BUILDING INSPECTION PERMIT

Permit Number: 040024

This is to certify that Goldeneye Corp /Risbara Br Construction
has permission to 3300 sf Single Family home rear deck, 2 car attached garage
AT 226 Hope Ave 392 A015001

CHECK-LIST AGAINST ZONING ORDINANCE

RE: PORCH & DECK DETAIL

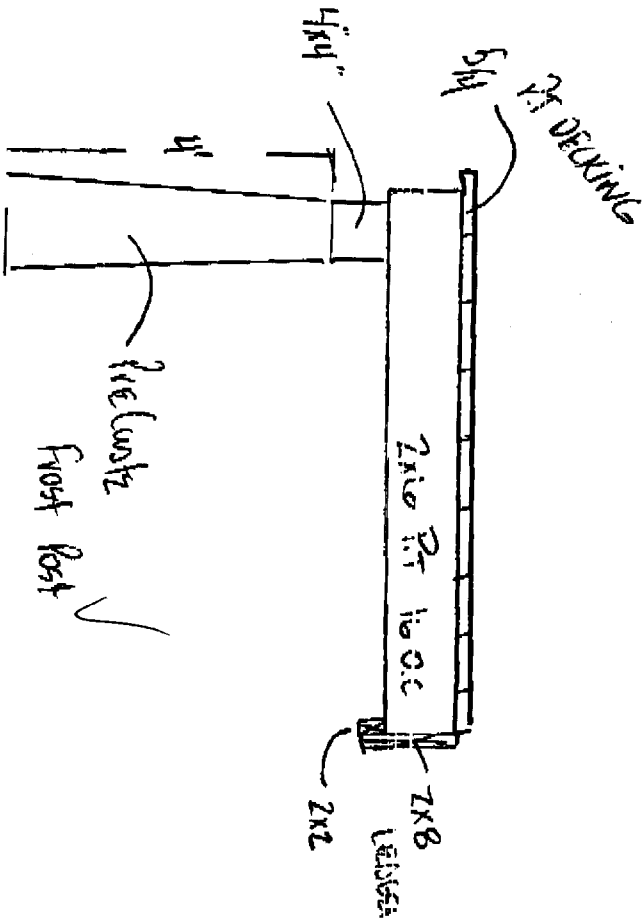
(12) Framing of deck + ~~front porch~~ & front porch
 NOT shown. See FAXES.
 (13) Lam beams - what typ? (i.e. LVL's, Parallam's etc?)

Front Porch Detail

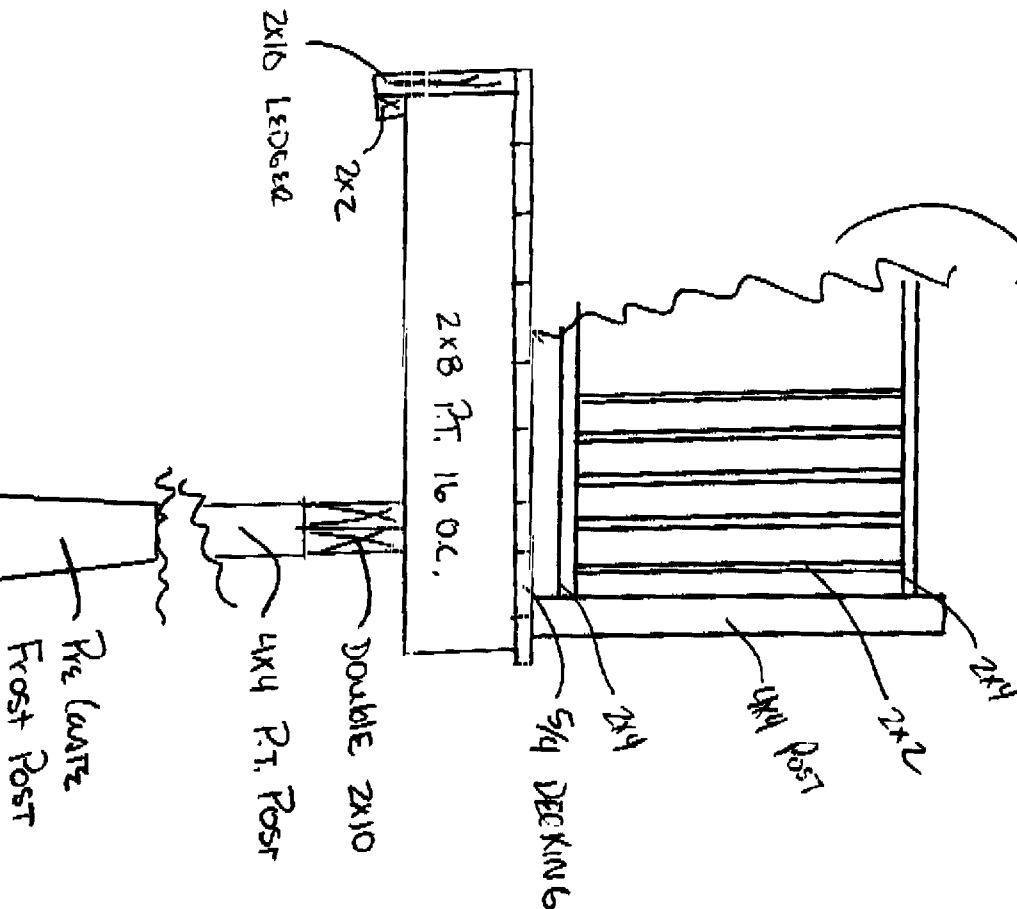
Header Schedule	Not shown	see
Type of Heating System	Not shown	fax
Stairs Number of Stairways 4 Interior 2 Exterior 2 Treads and Risers (Section 314) OK Width OK Headroom OK Guardrails and Handrails (Section 315) - shows 34" - see fax - 36"		
Smoke Detectors Location and type/Interconnected	OK	
Plan Reviewer Signature

HEIGHT PER ADA CODE
36"
